Proposal for a new UN Regulation on uniform provisions concerning the approval of devices for reversing motion and motor vehicles with regard to the driver's awareness of vulnerable road users behind vehicles

Red: Update from previous document

Green: [OICA comments or proposals] Review in progress in OICA.

Figure 3
Class VIII field of vision

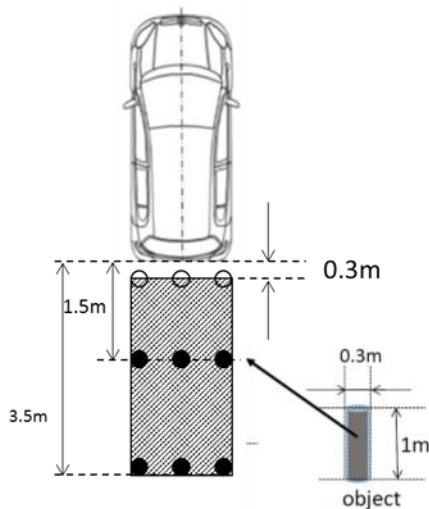
[OICA PROPOSAL]
